IMPROVEMENT PERMIT for a RESIDENTIAL ON-SITE WASTEWATER TREATMENT & DISPOSAL SYSTEM

Permit #: **30002051** GWS File #: **5767B** Tax Parcel #: **199-361-33**

SEPTIC SYSTEM DESIGN REVIEW WORKSHEET

Reference: **Revision of Septic Improvement Permit for Lot 175 at the Sanctuary at Lake Wylie**
Mecklenburg County Health Department (MCHD) File #5767B

SCALE: AS SHOWN	DRAWN BY: RDM	CHECKED BY: JP
JOB NO. 1588-05-067	DATE: MARCH 2007	FIGURE NO 1

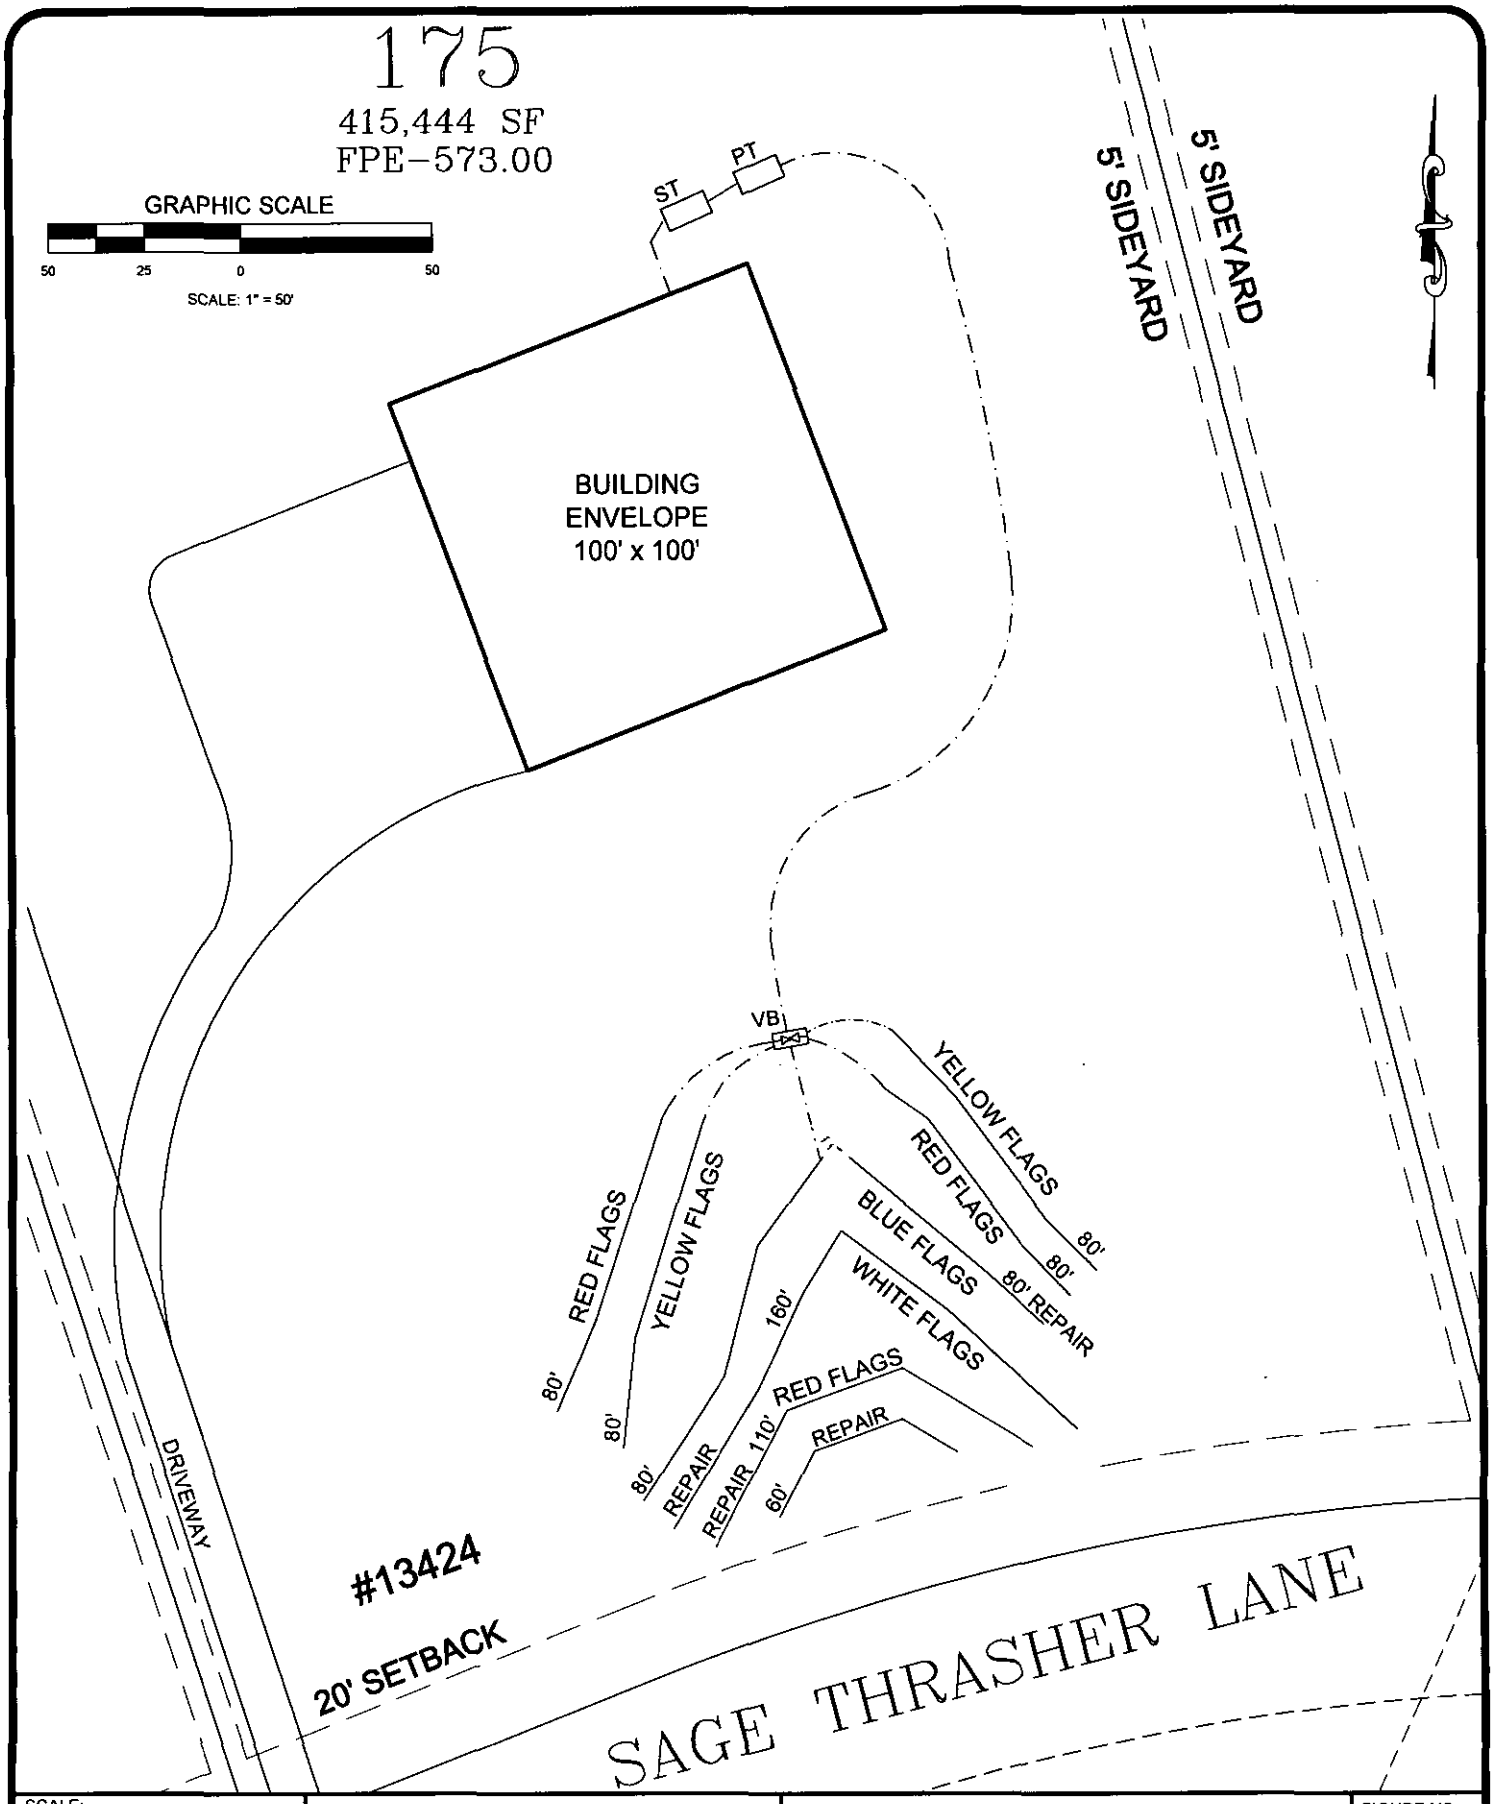
① & FINAL DESIGN WILL REQUIRE 1½" Ø SCH 40 PVC FOR LATERALS IF LENGTH EXCEEDS 70'.

② MAY REWORK LATERALS TO BE ≤ 70' AND USE 1¼" Ø SCH. 40 PVC.
